VALLEY CAMP OF UTAH, INC.

Re: Update of Mining Permit Application

This document is submitted in response to the "Remaining Permit Application Package (PAP) Inadequacies" as delivered to Valley Camp on October 14, 1983.

FIGURE 3-35. Gradation curve for Riprap. Adapted from the U.S. Dept. of Transportation Circular 11.

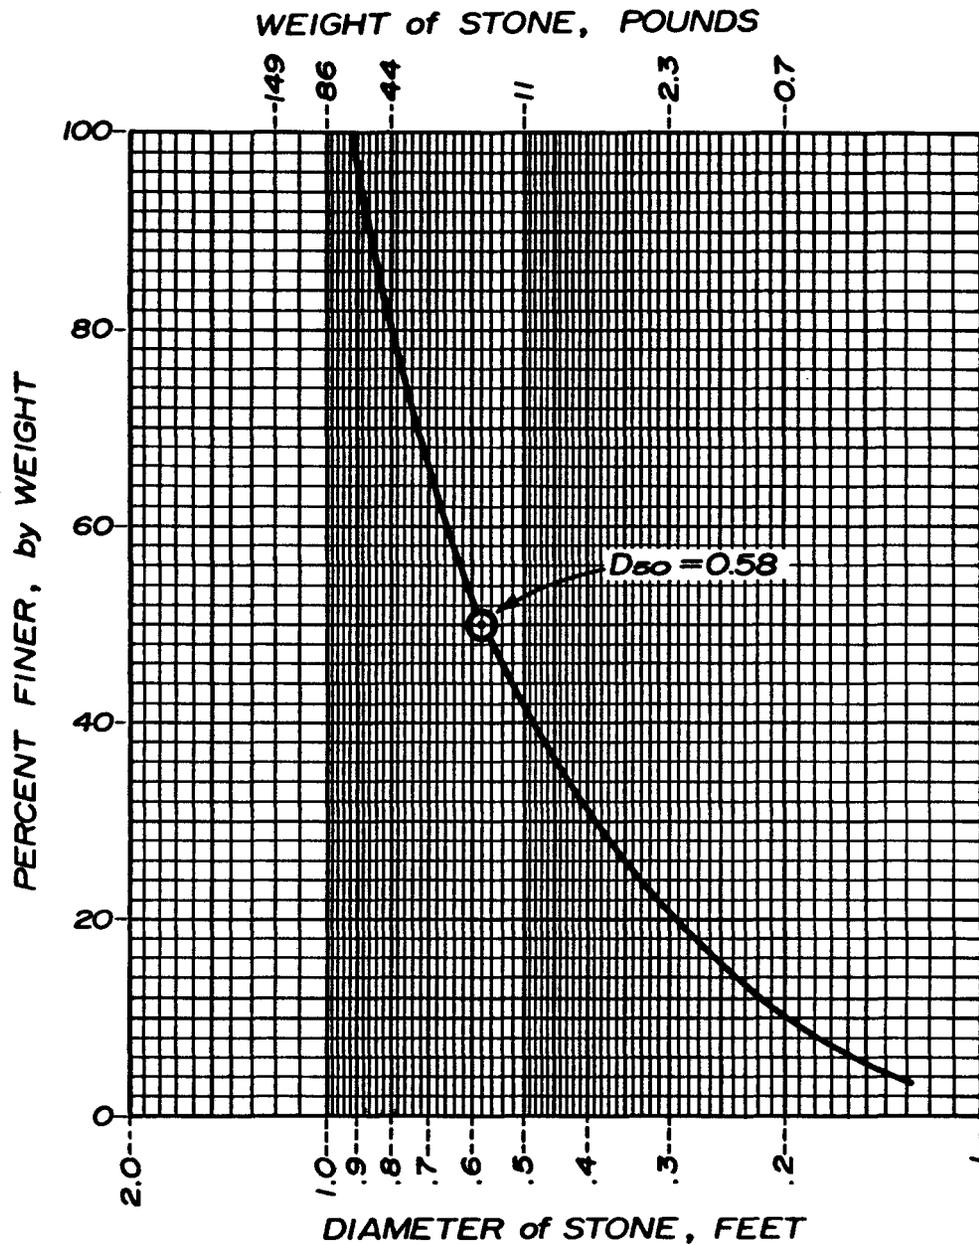
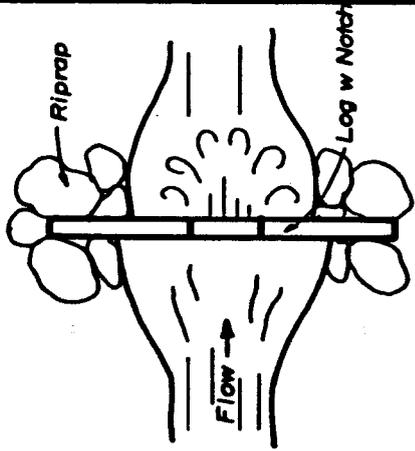
2. Figure 3-35, attached, provides a riprap gradation curve for the reconstructed stream channel. The mean diameter of the riprap was determined by the techniques presented in the National Cooperative Highway Research Program, "Research Results Digest". The calculation is presented on Figure 3-33.

Figures 3-35 and 3-36 will be inserted into section UMC 784.22 of Volume VI, along with revised page No. 784.22-2 upon final approval.

Figure 3-36

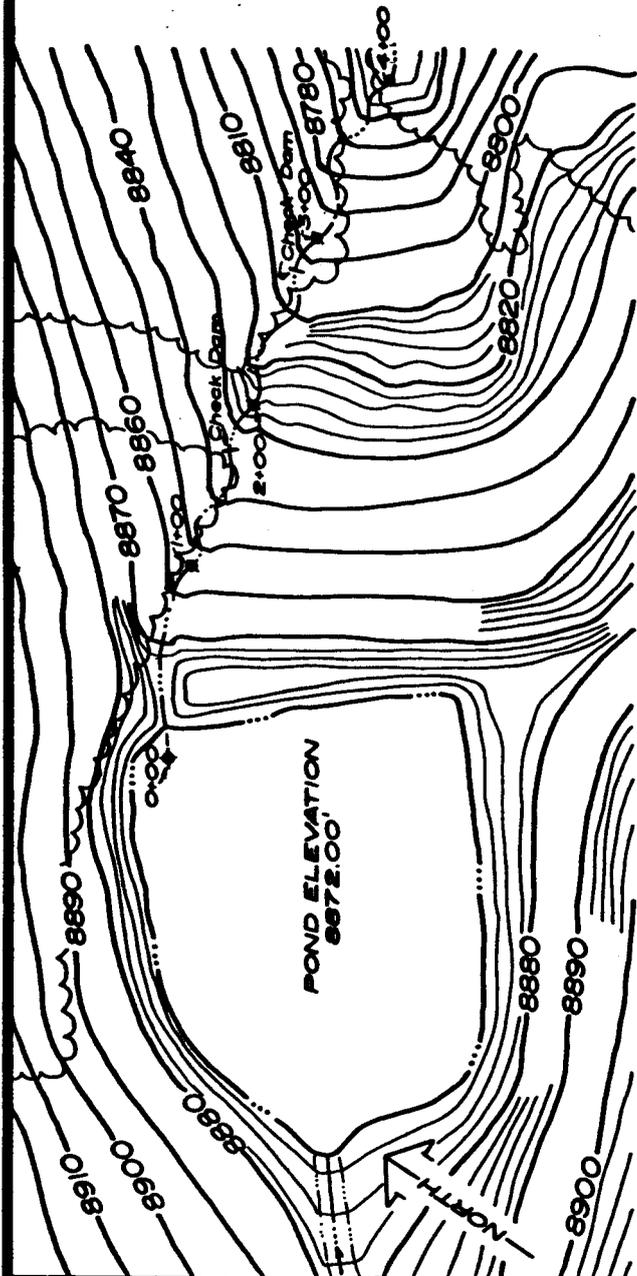
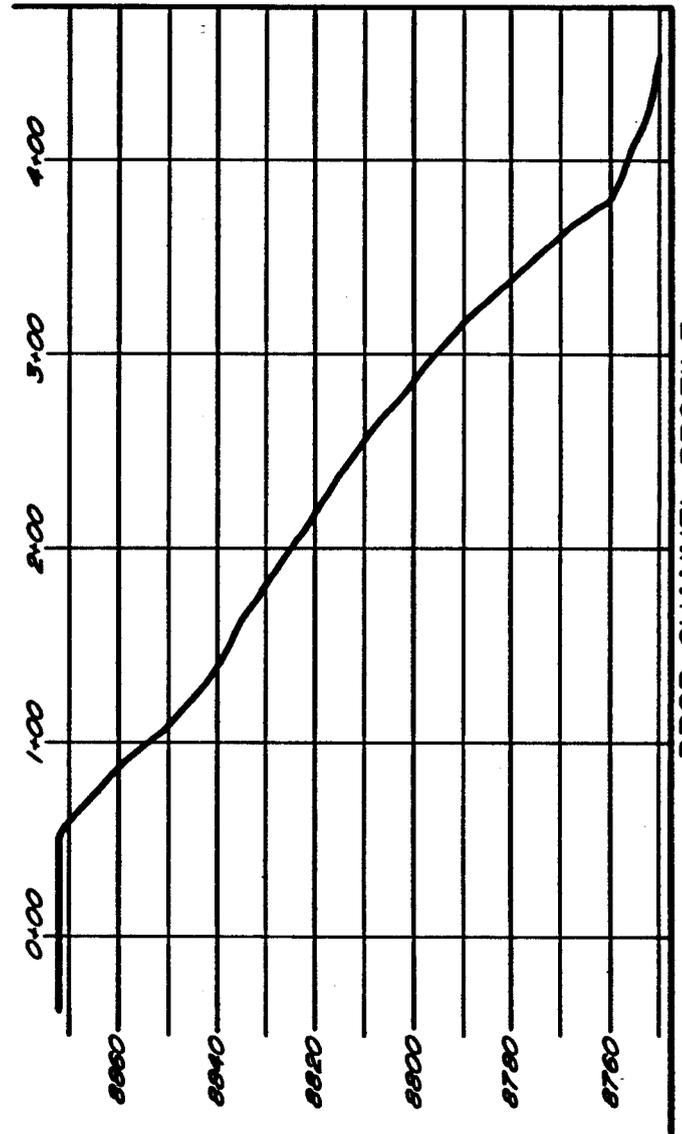
3. A plan and profile drawing of the drop channel (sediment pond spillway) is included as Figure 3-36.

For as-built design, plans and construction specifications for the channel drop section, please refer to the Golder Associates report found in Appendix A, Volume V.
